## 4 Masterplan & Public Realm

# 6 Comparison Drawings

The following pages contain a series of comparison drawings to allow the amended design changes to be reviewed directly alongside the original approved planning drawings.

### 6.4.1 Section 01

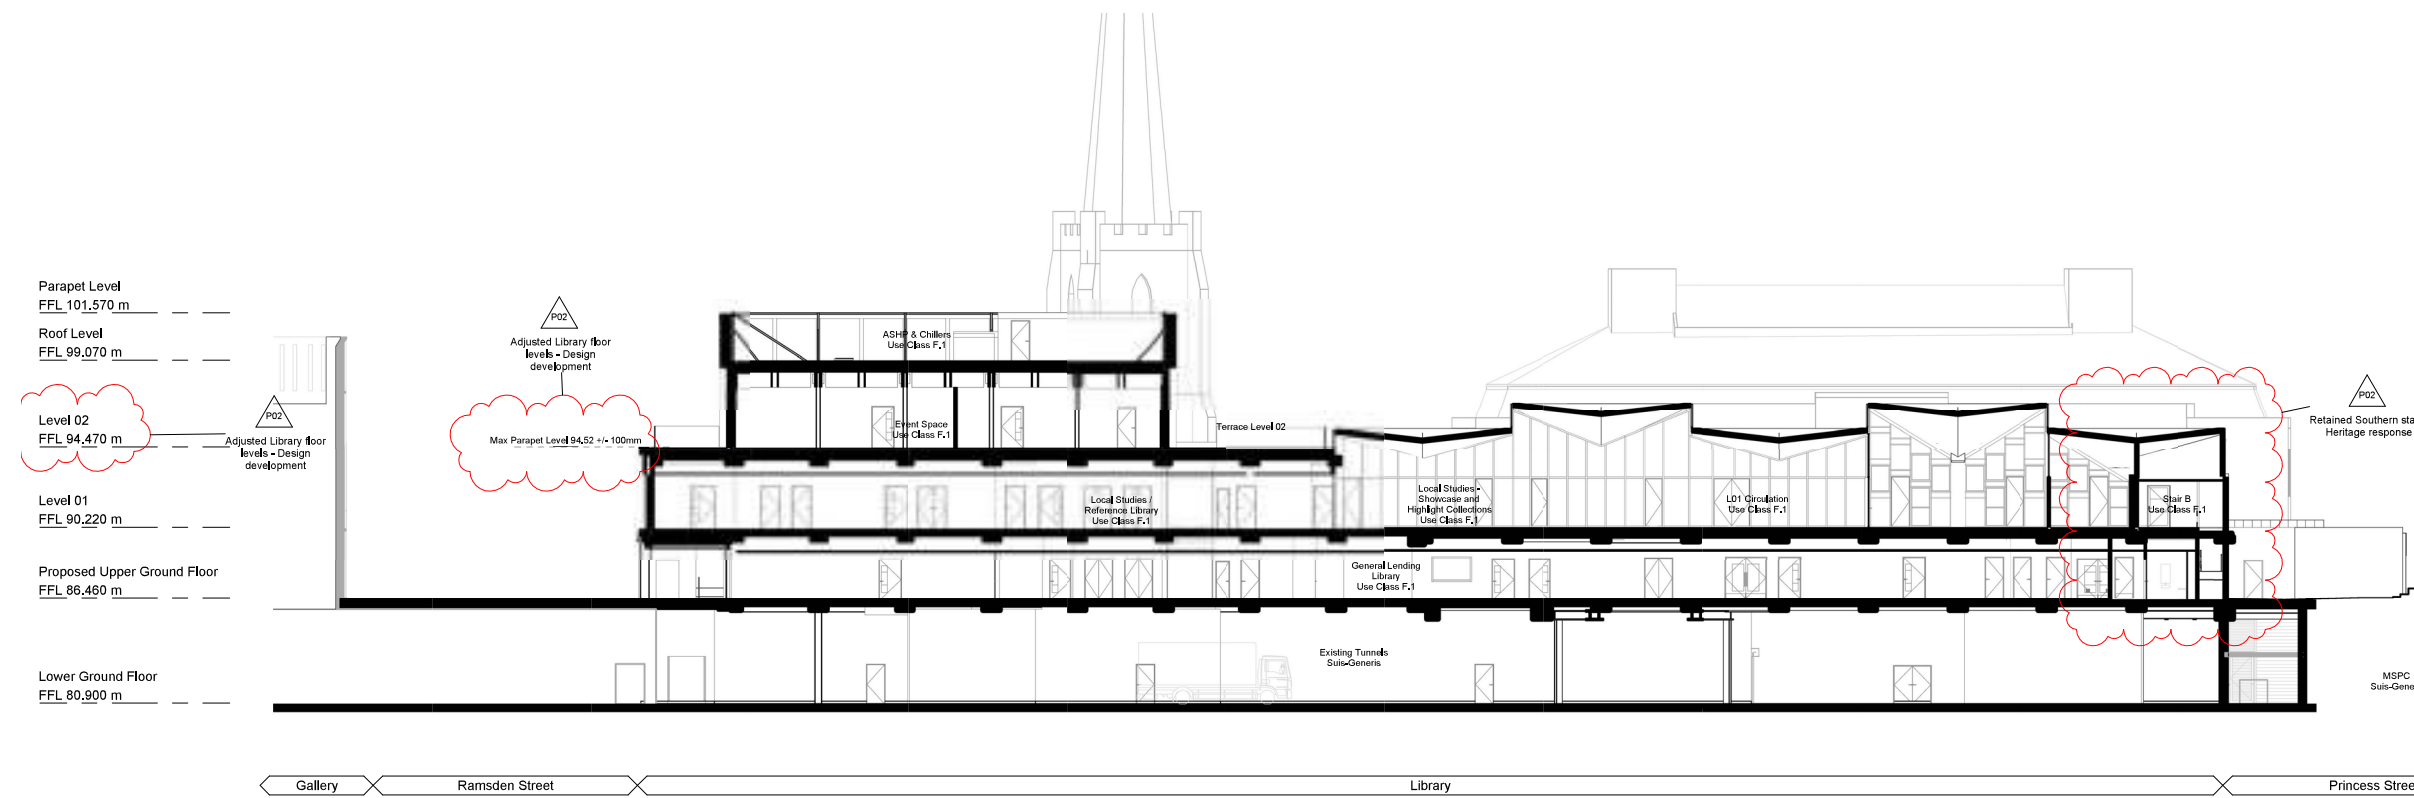
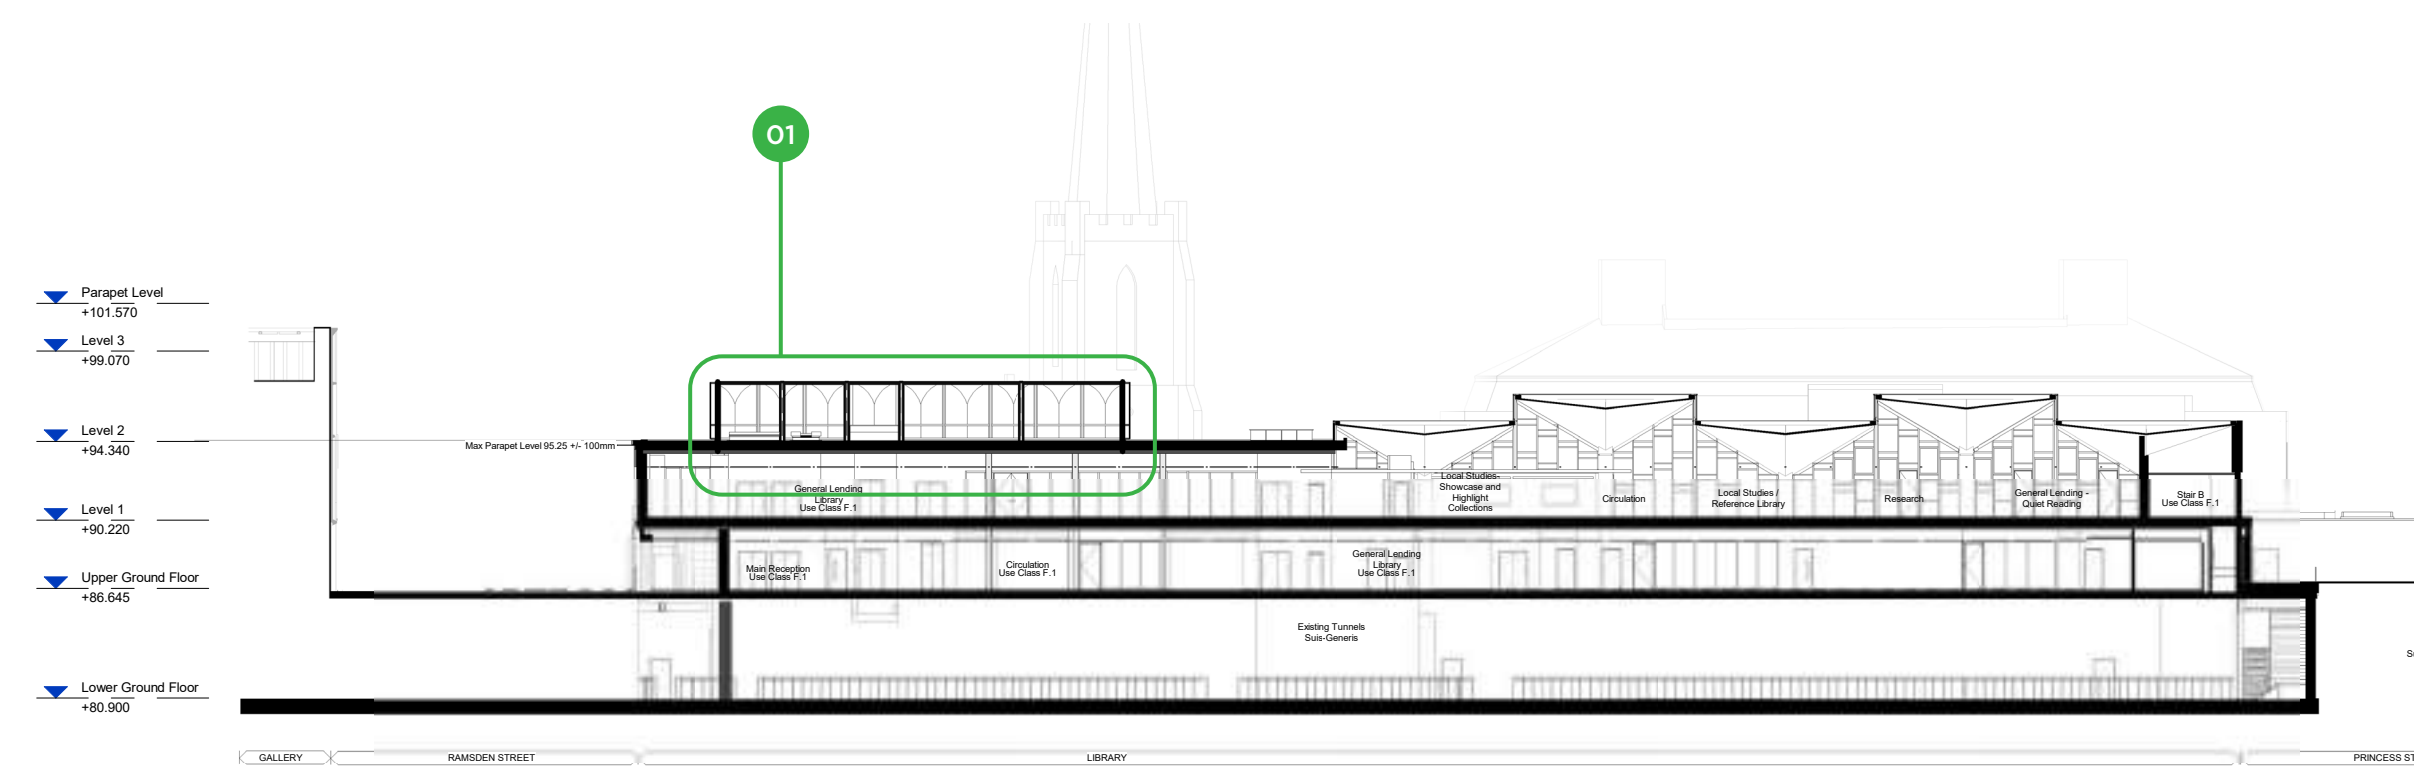
- 01 Omission of accommodation at second floor (event space and multi-purpose room) and relocation of plant enclosure down to this level.

### 6.4.2 Section 02

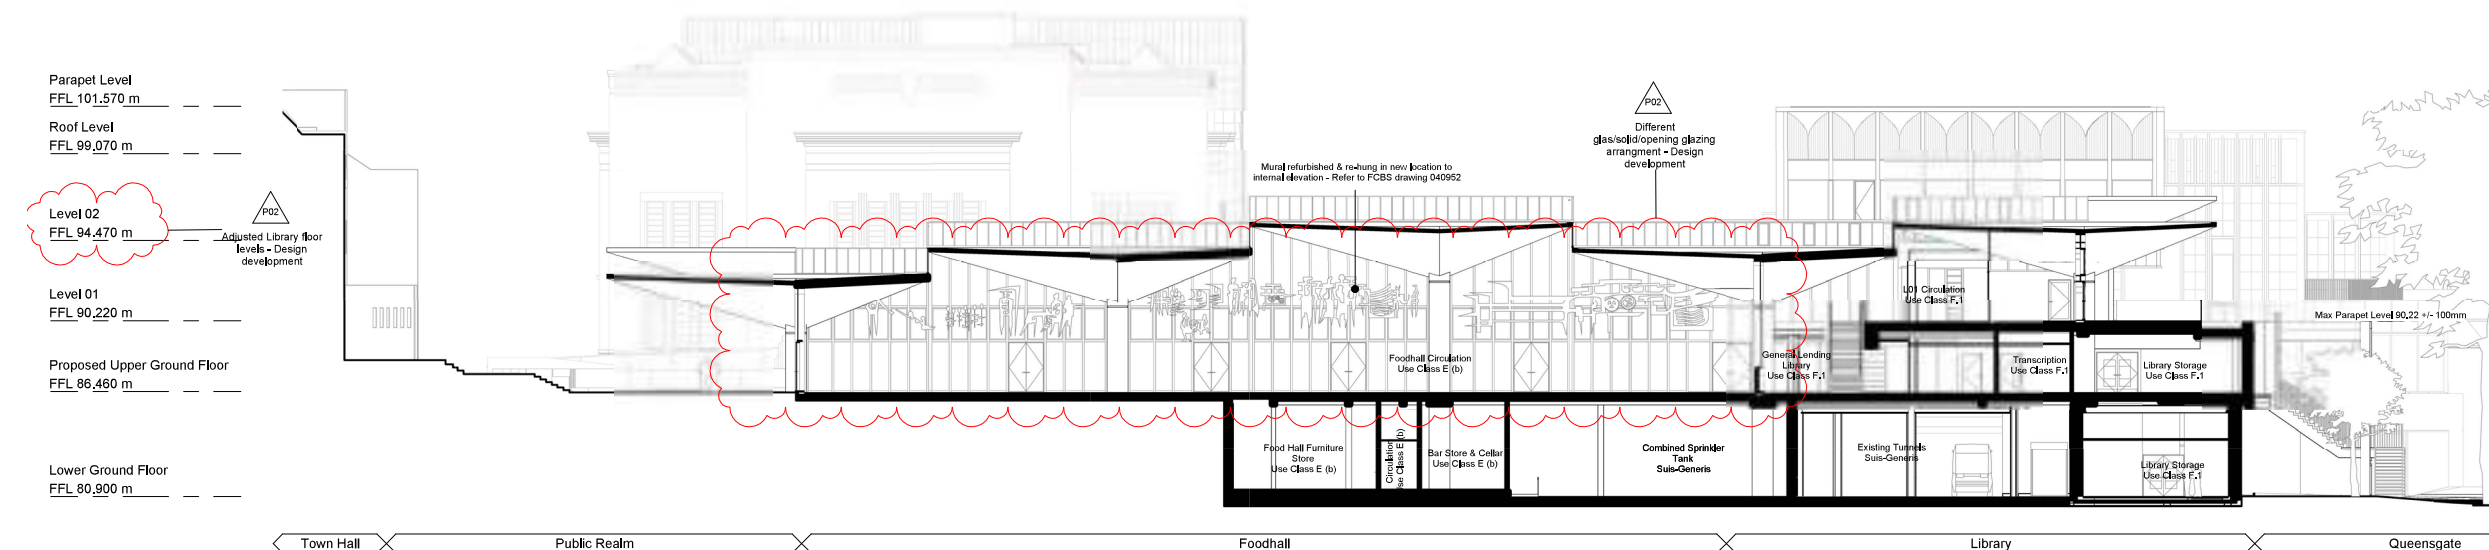
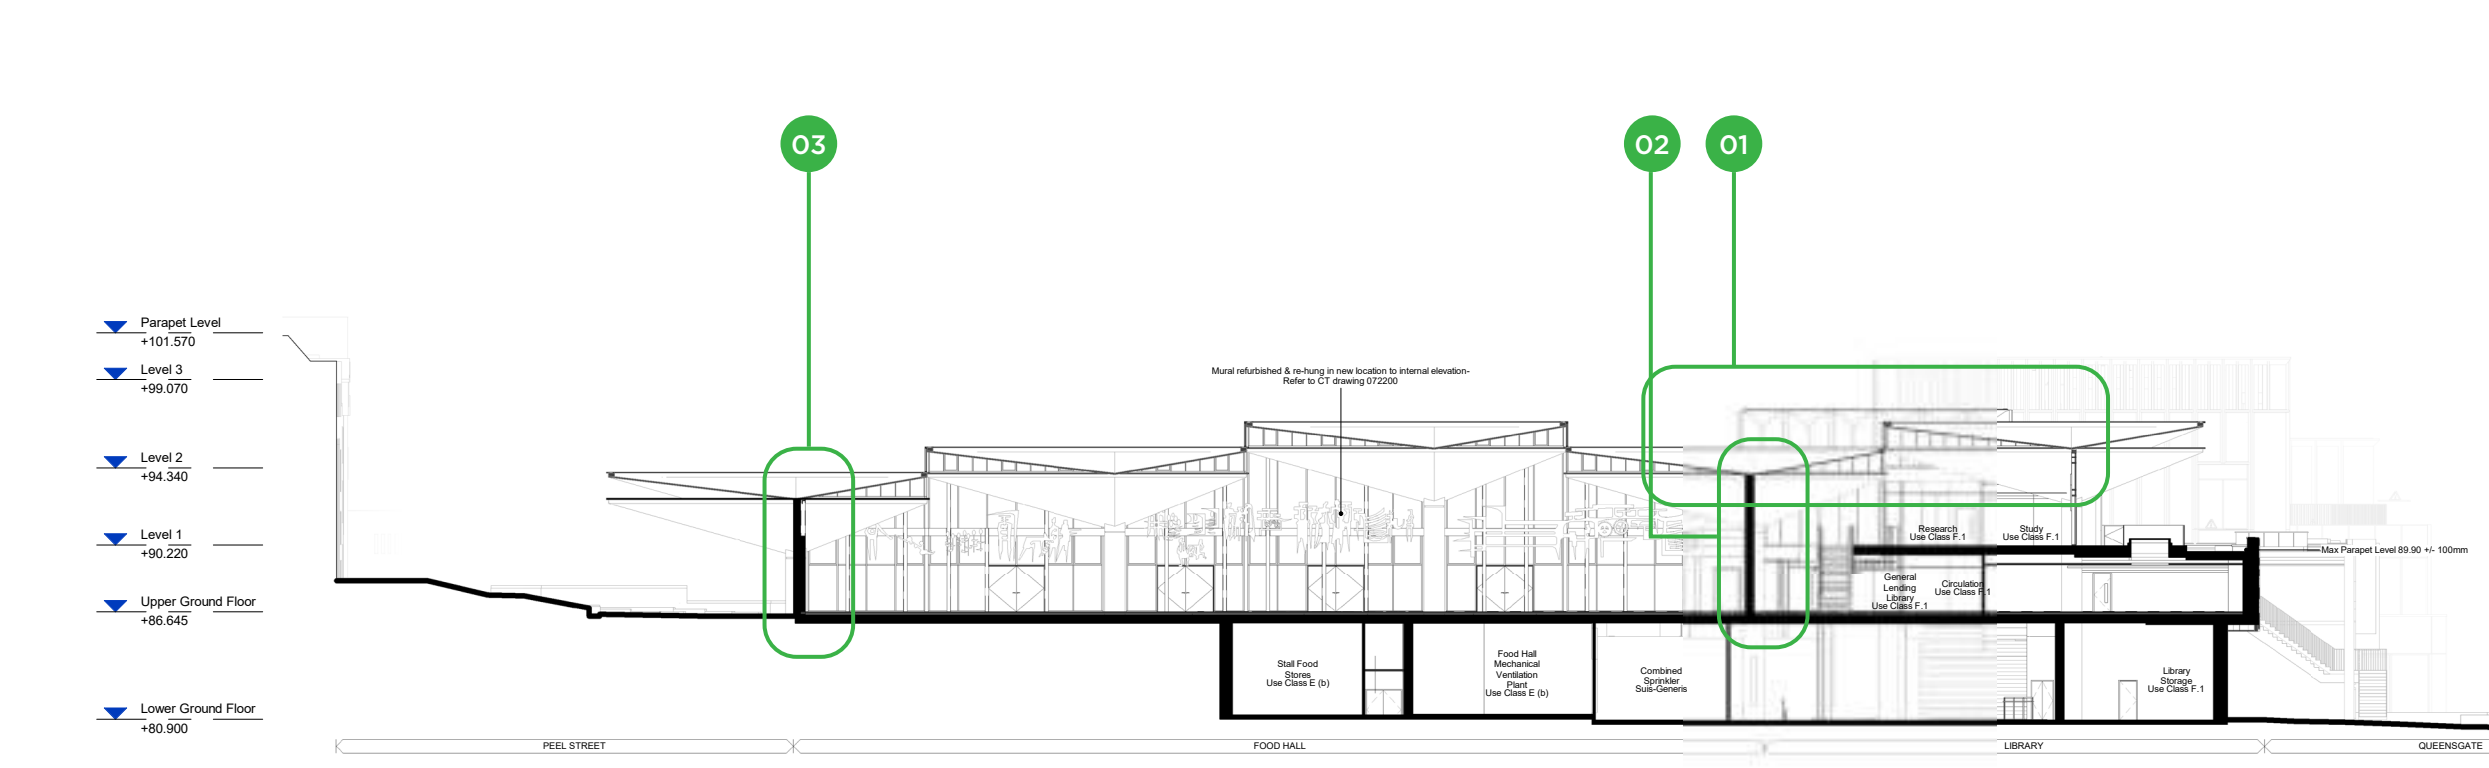
- 01 Omission of accommodation at second floor (event space and multi-purpose room) and relocation of plant enclosure down to this level.
- 02 Introduction of solid wall with fire rated windows instead of fire rated curtain wall glazing.
- 03 Introduction of solid cladding to west elevation of Food Hall.

6.4.3 Section 03

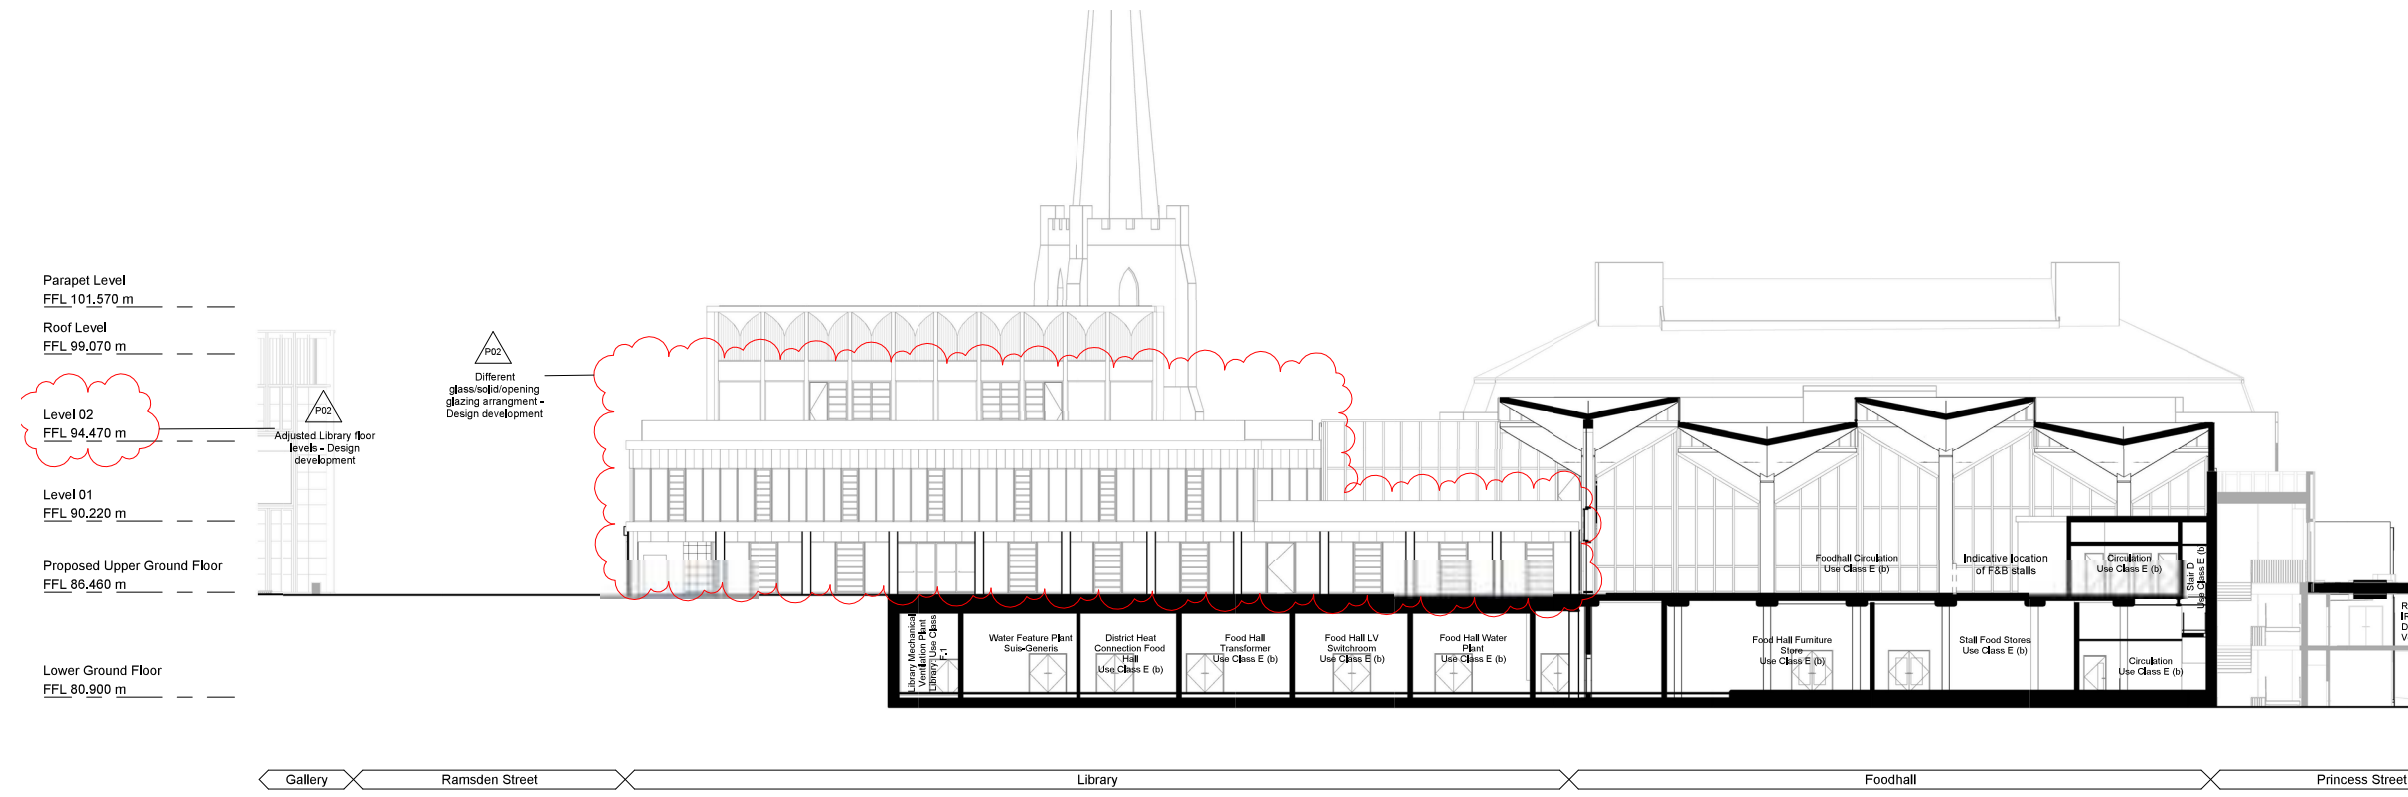
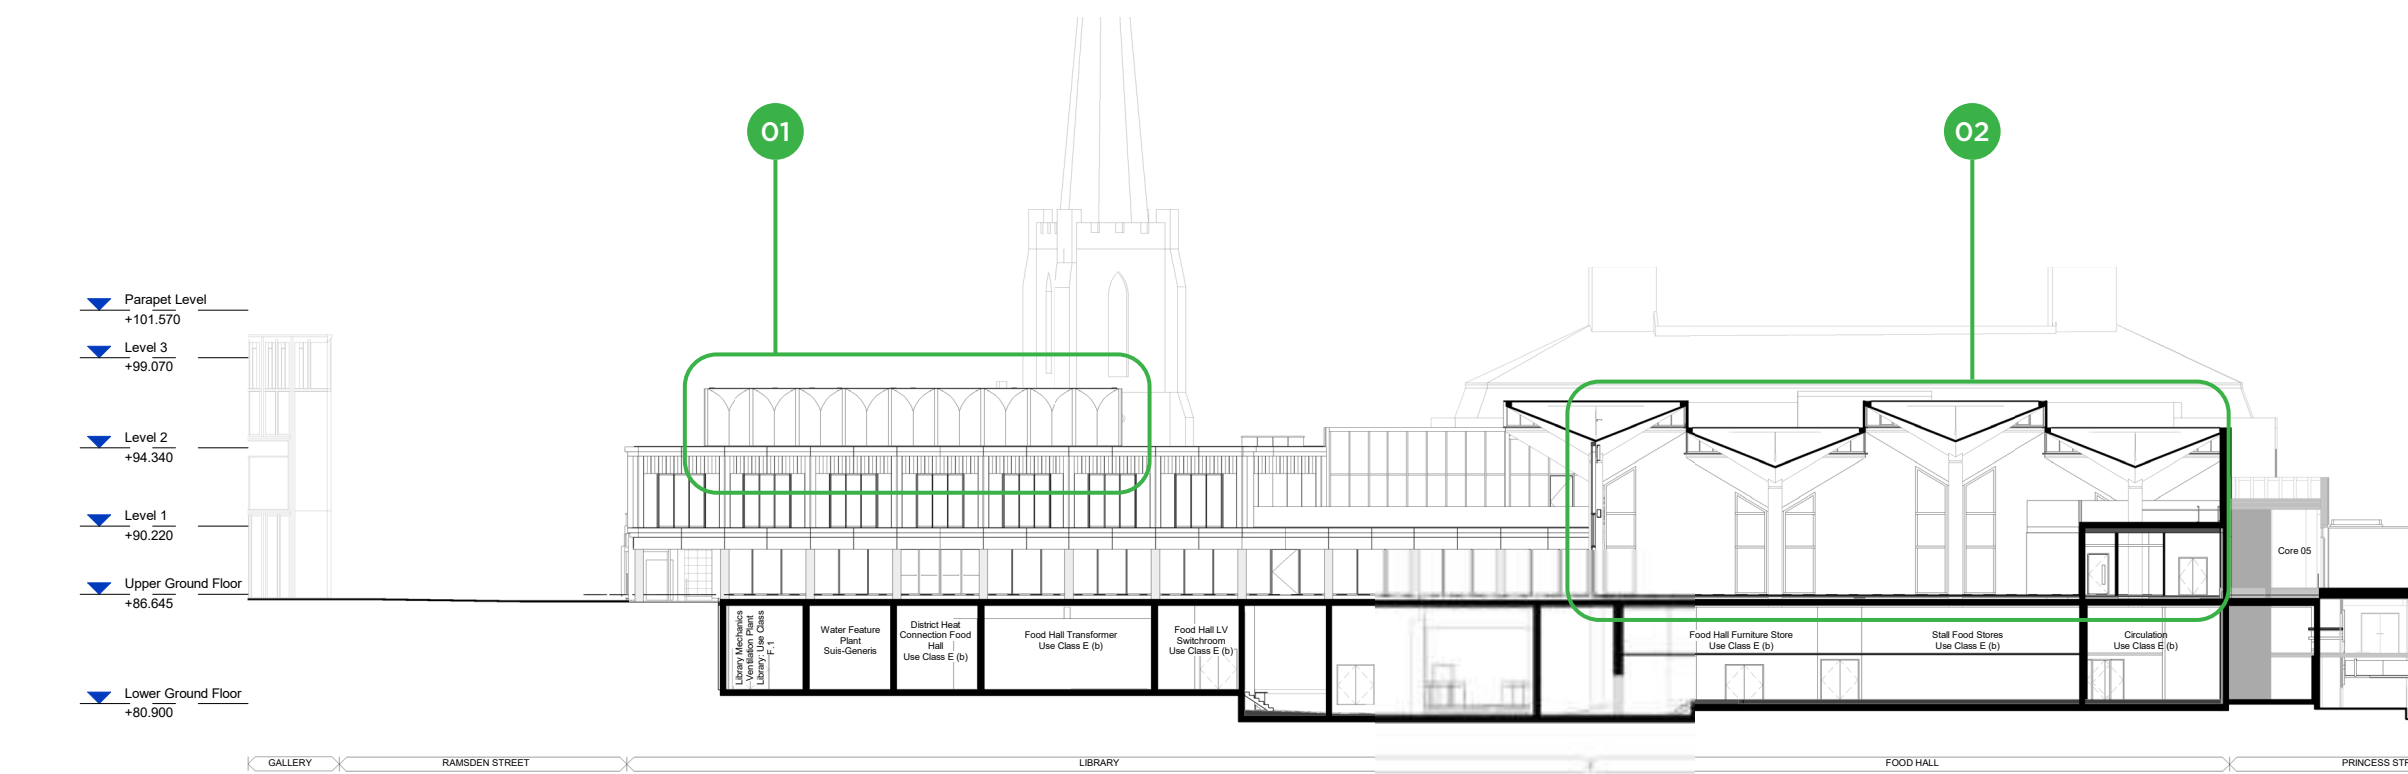
- 01 Omission of accommodation at second floor (event space and multi-purpose room) and relocation of plant enclosure down to this level.
- 02 Introduction of solid wall with fire rated windows instead of fire rated curtain wall glazing.
